## **Proposals to clarify the provisions of Regulation No. 51, Revision 3, Annex 7**

Transmitted by the experts from ISO

Informal document GRB-64-04  
(64th GRB, 5-7 September 2016,  
agenda item 4 (b))

**Figure 2 : Flowchart for the vehicle sound assessment according to Annex 7 Paragraph 5 “Reference Sound Assessment”**

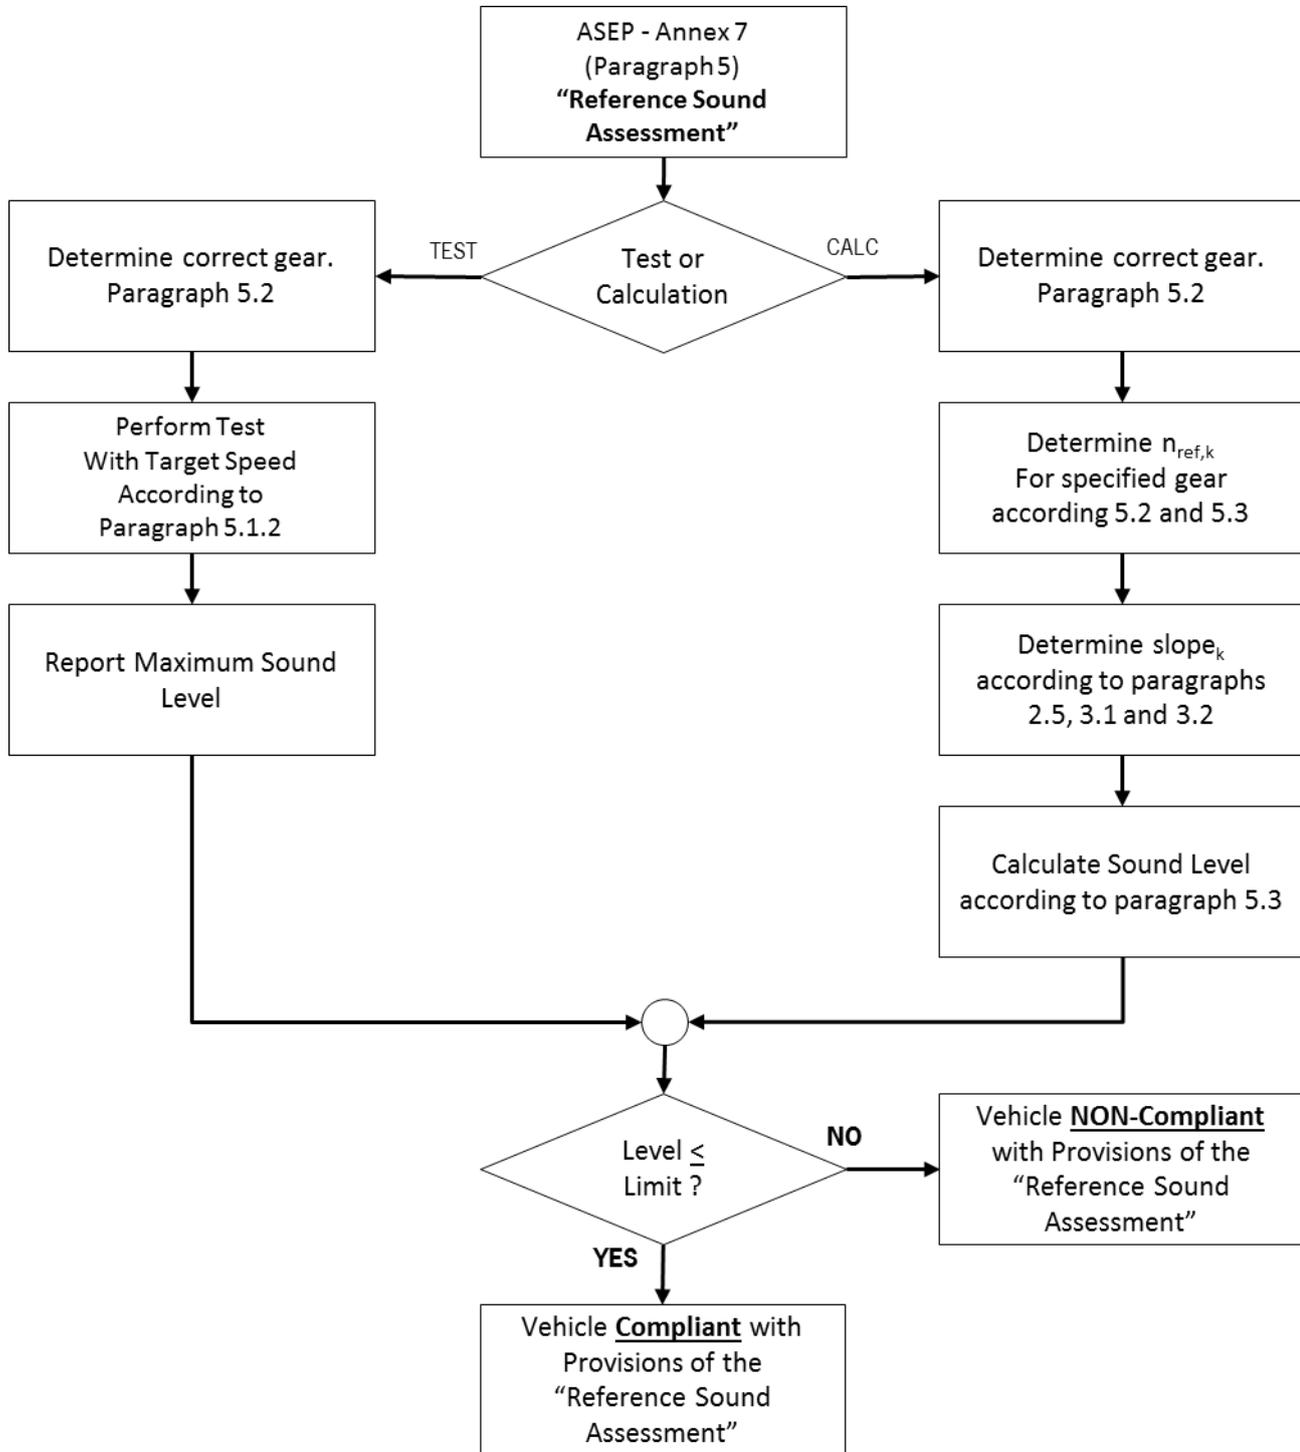
**The reference sound can be obtained by simulation or from direct measurement. The result of one assessment method has to comply with the specification of 5.4.**

For direct measurement, the reference sound is assessed at a single run in an acceleration condition started at line AA as specified in 2.6. The gear shall be as specified in 5.2 for vehicles tested in locked position or in D for vehicles tested in non-locked position.

The target test speed  $v_{aa}$  is equal to 50 km/h  $\pm$  1 km/h unless  $v_{bb}$  exceeds 61 km/h.

If  $v_{bb}$  exceeds 61 km/h, the target test speed  $v_{bb}$  shall be set to 61 km/h  $\pm$  1 km/h. The entry speed shall be adjusted to achieve the target test speed.

**Figure 3 : Flowchart for the determination of the individual test points Pj according to paragraph 2.**

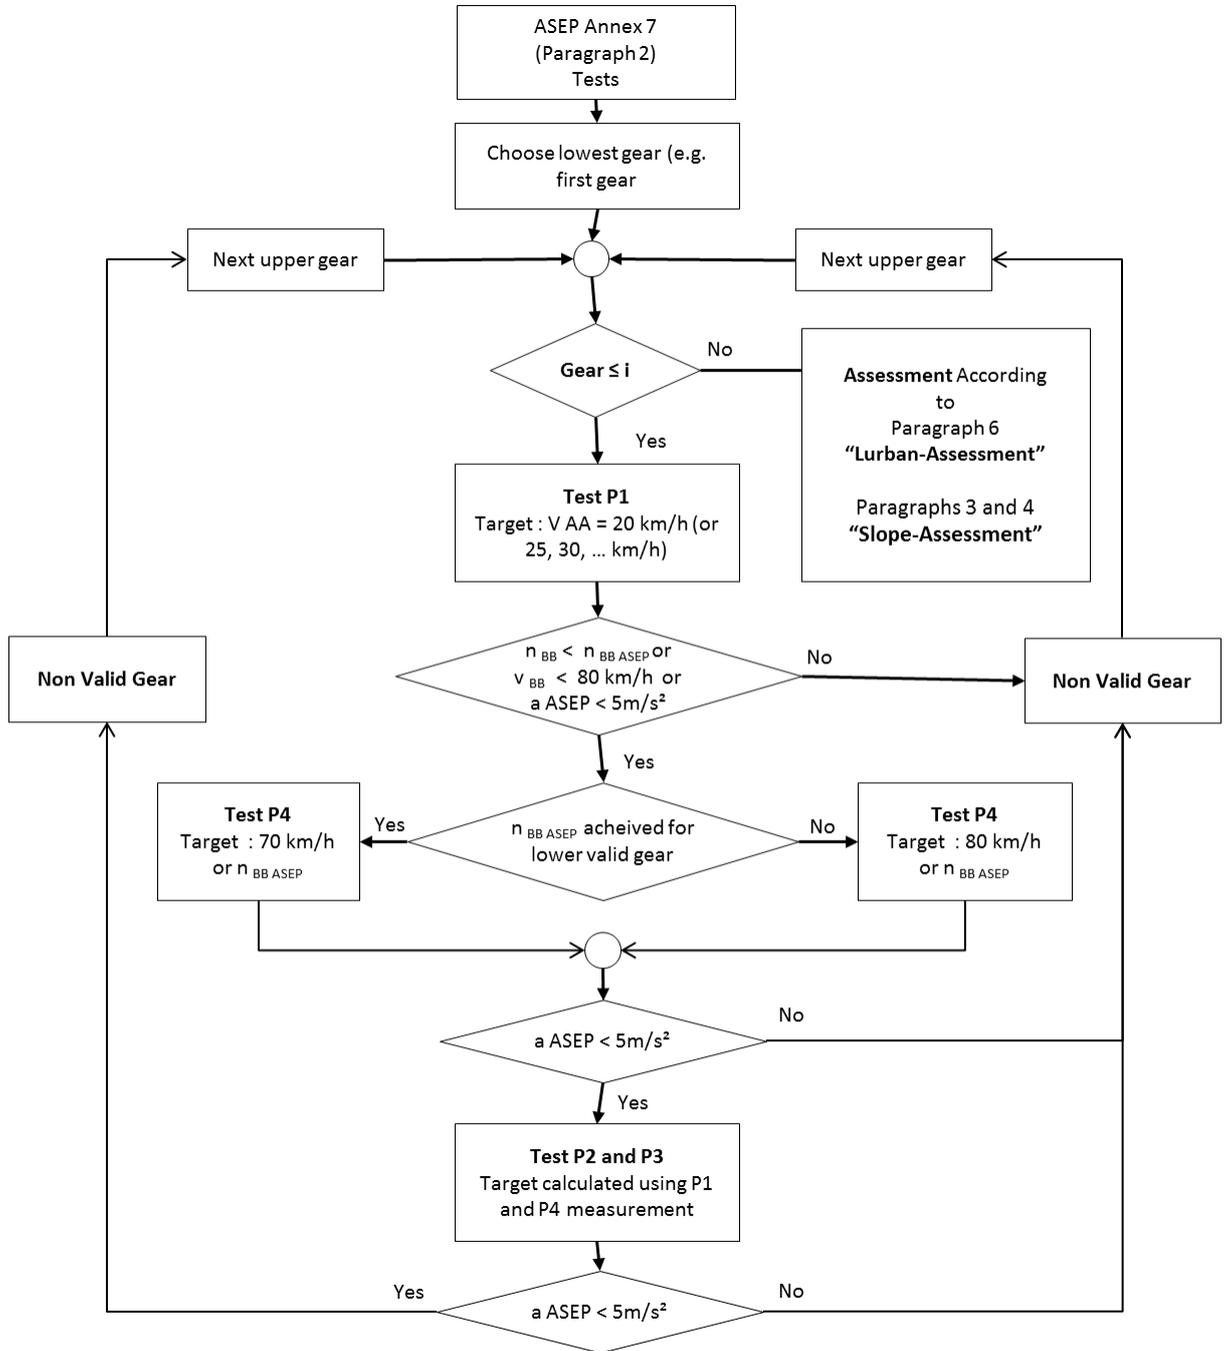
The sound emission shall be measured in each valid gear ratio at the four test points as specified below. **For all test points the boundary conditions as specified in paragraph 2.3. shall be met.**

**The gear ratio is valid if all four points and the anchor point meet the specifications of paragraph 2.3.**

**The test speed for the fourth test point  $P_4$  in any gear is defined by either :**

- **~~0.95~~  $n_{BB\_ASEP} \leq n_{BB\_4} \leq n_{BB\_ASEP}$  or**
- **$3 \text{ km/h} \leq V_{BB\_4} \leq V_{BB\_ASEP}$  with  $V_{BB\_ASEP}$  as defined in paragraph 2.3.**

Test Point  $P_j$ :  $v_{BB\_j} = v_{BB\_1} + ((j - 1) / 3) * (v_{BB\_4} - v_{BB\_1})$  for  $j = 2$  and  $3$  **with a tolerance of  $\pm 3 \text{ km/h}$**
